**DESIGN REVIEW/CERTIFICATE OF APPROPRIATENESS APPLICATION**

| Project/Property Address or Location:<br><b>1130 Morrison Road</b>  |  | Project Name/Business Name (if applicable):<br><b>McNeilus Truck Manufacturing, Inc.</b>                    |   |

1150 MORRISON ROAD GAHANNA, OHIO

## Development Plan Review Response 2017050301

BUILDING ELEVATIONS

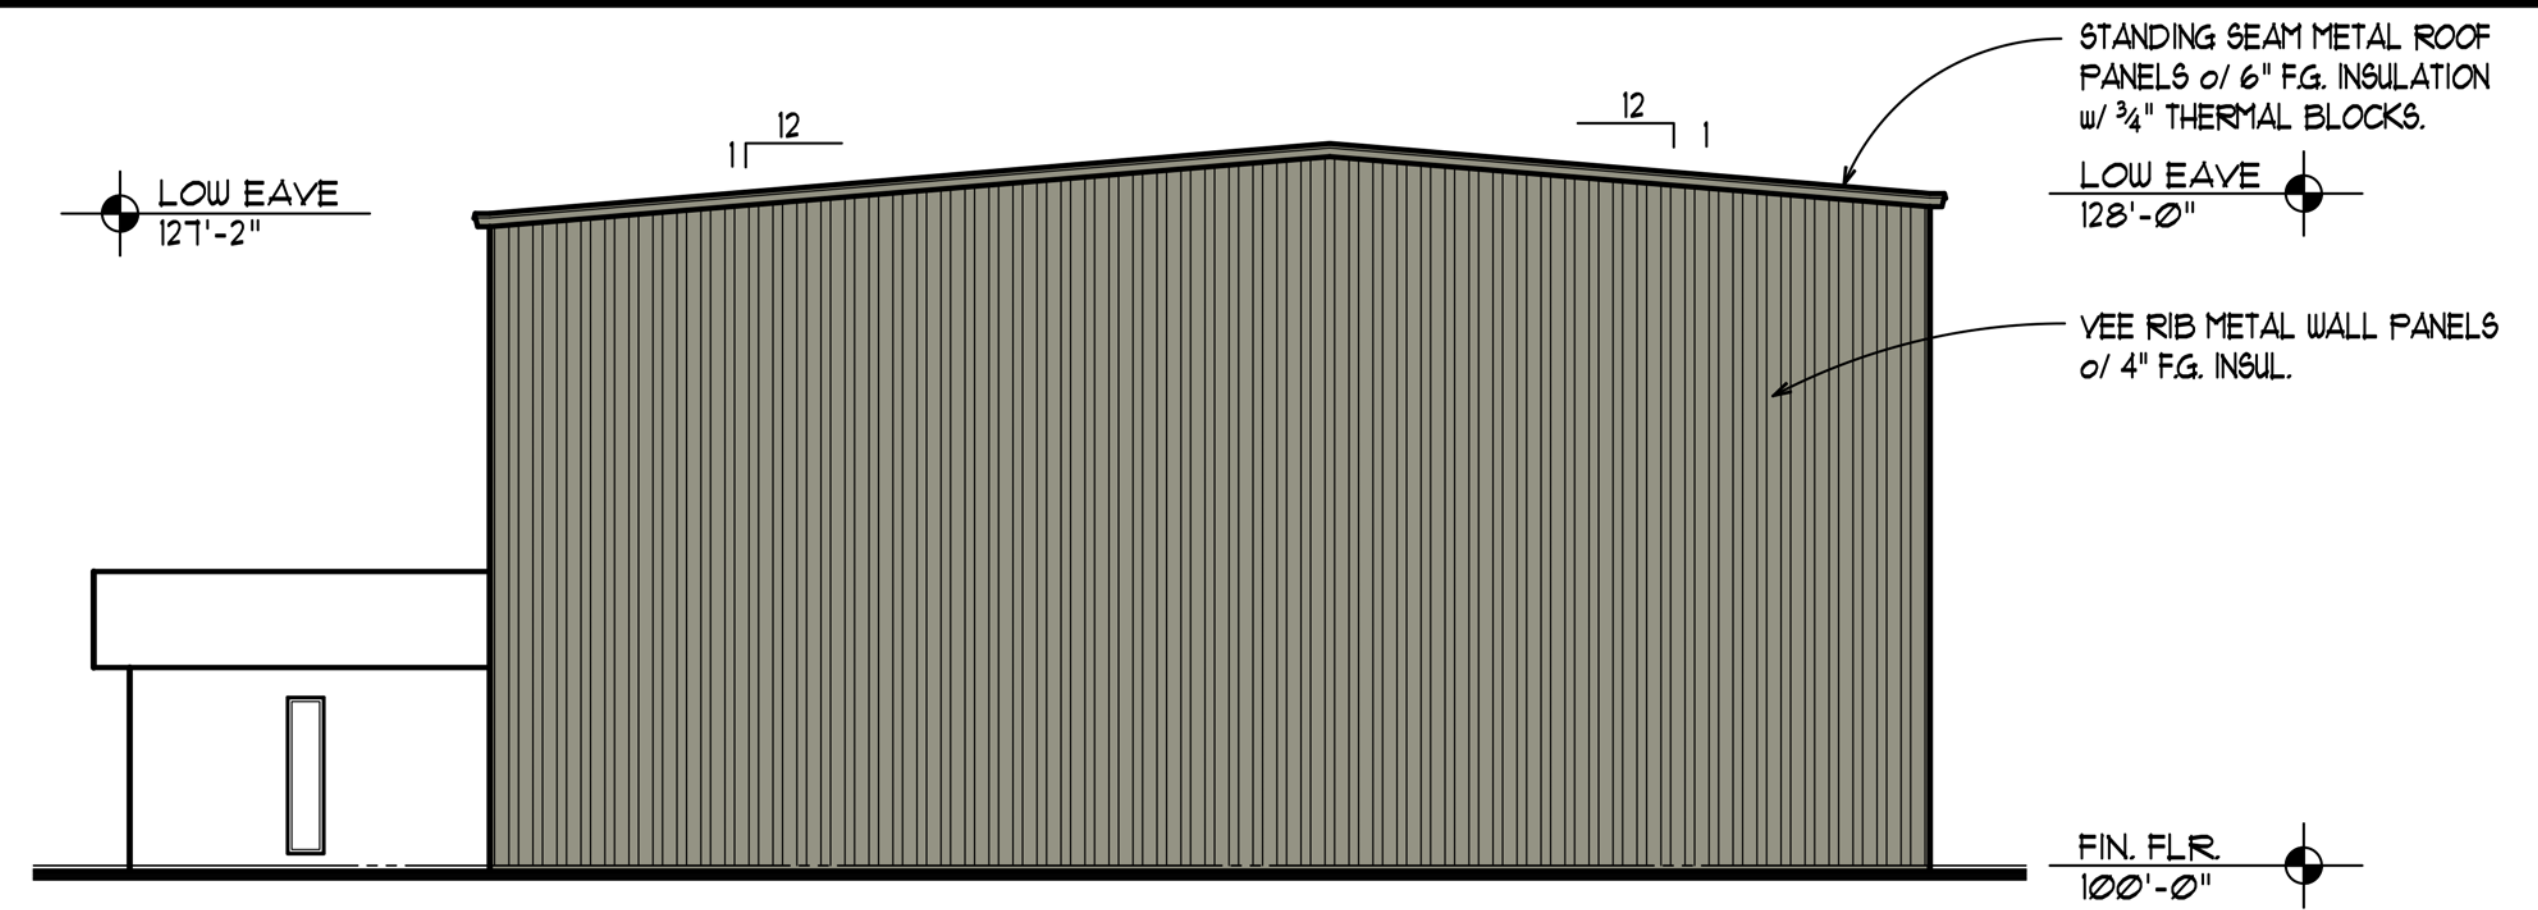
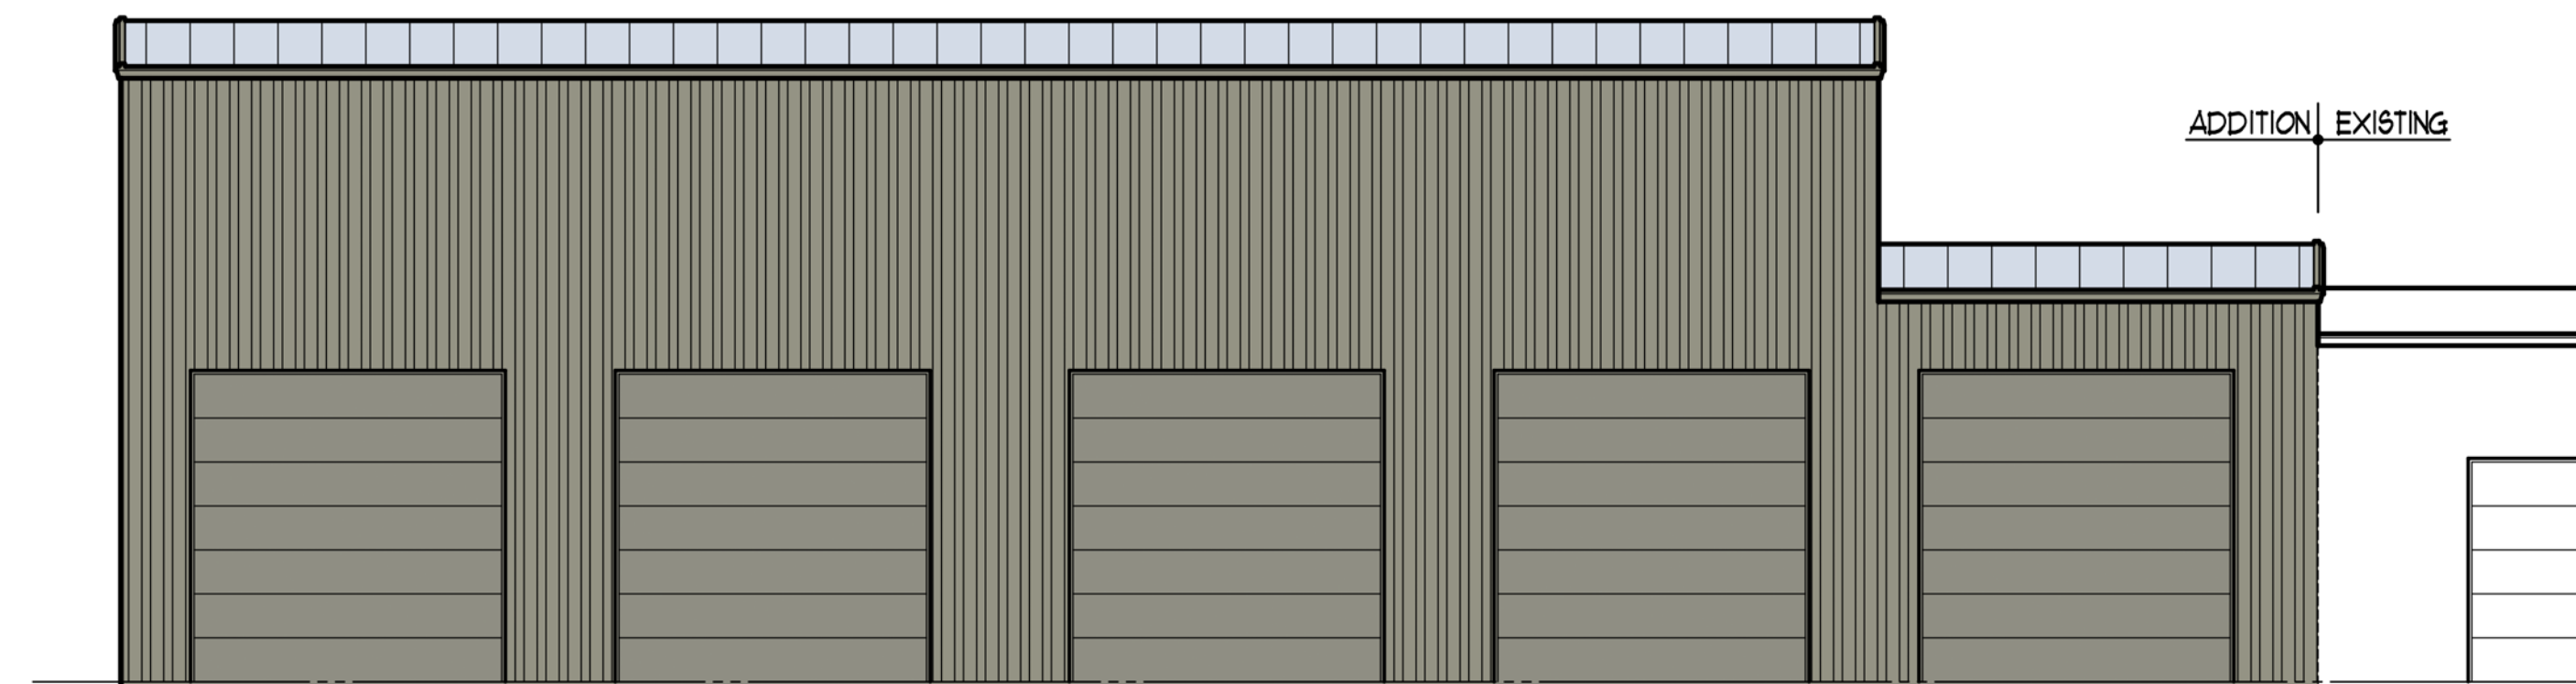
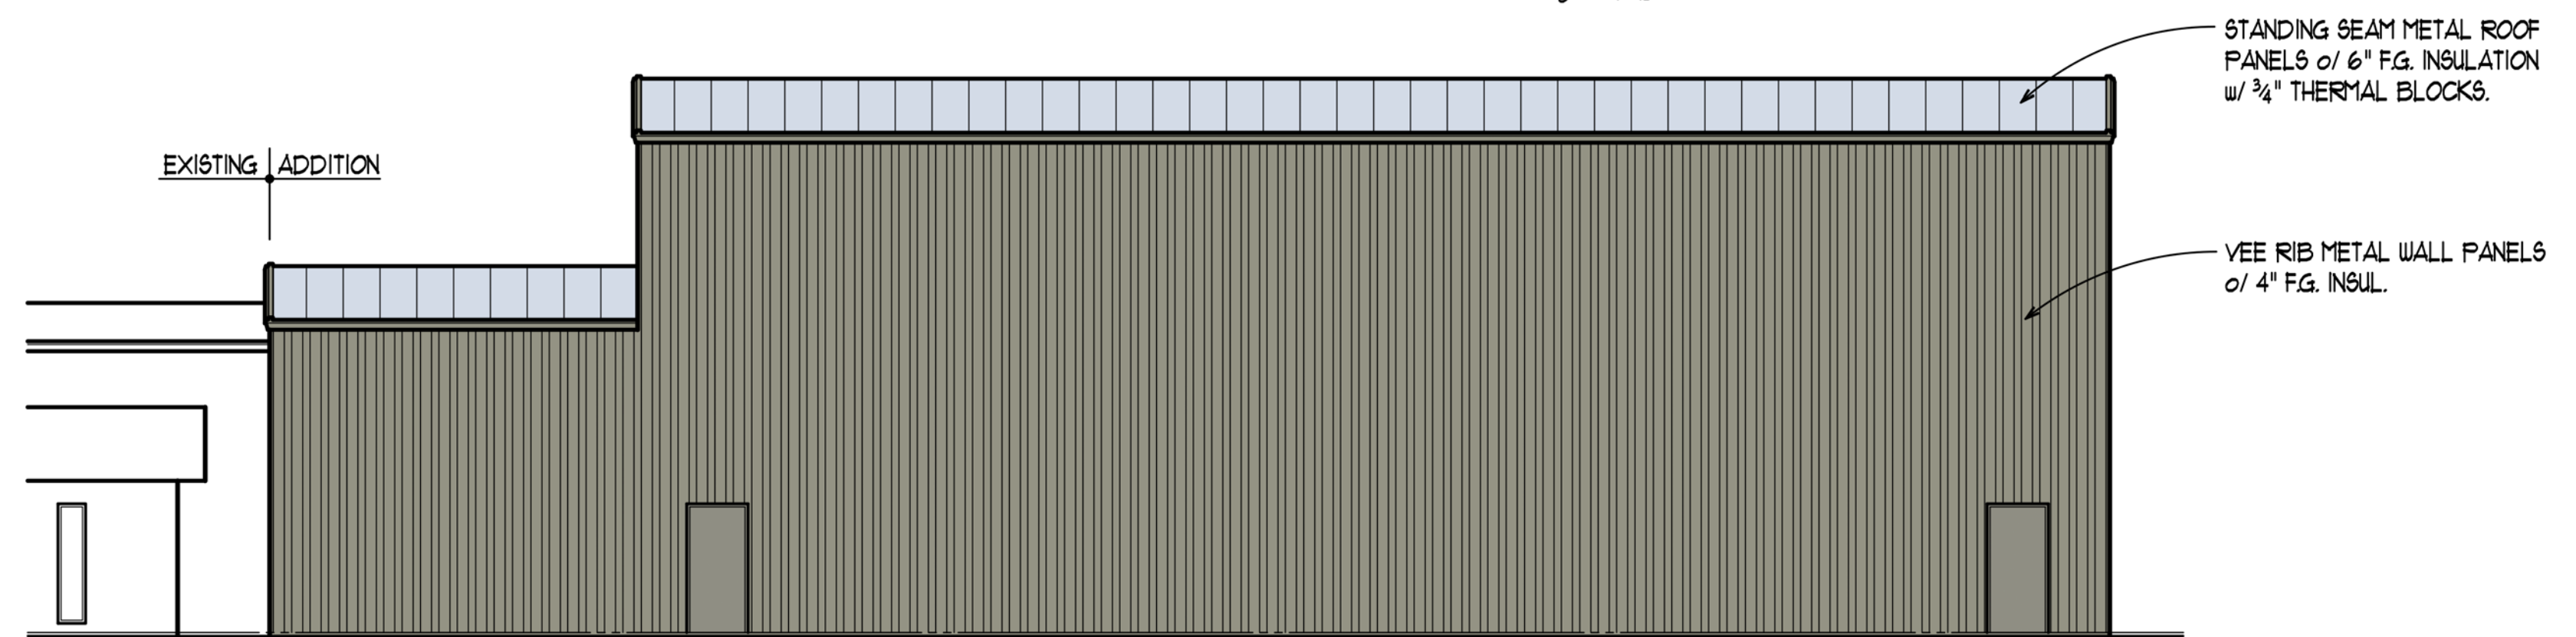
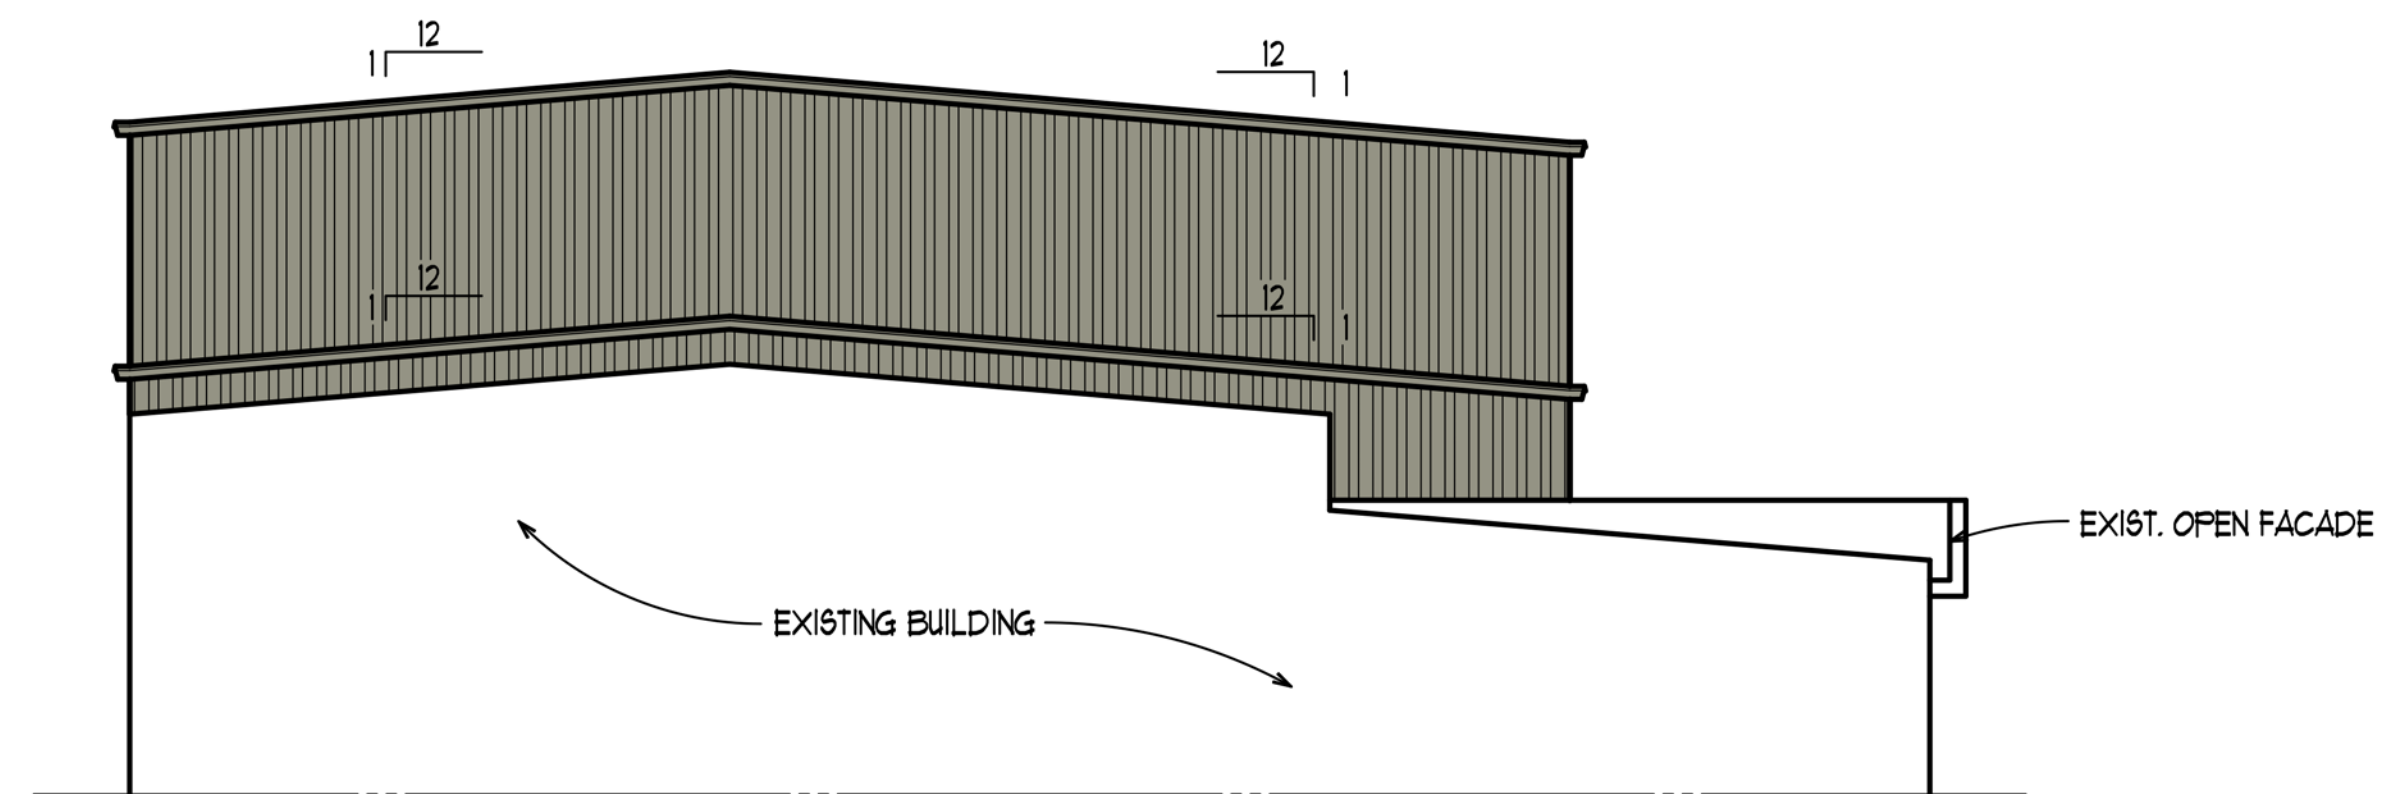
*The application does not contain a materials list so it is difficult to determine compliance with the applicable standards. Additionally, it is Planning and Development staff's opinion that the renderings do not meet some of the objectives of the district, specifically enhancement of the district through visual appeal and the use of windows as practical. Staff recommends that the building incorporate additional materials and/or windows to add visual appeal.*
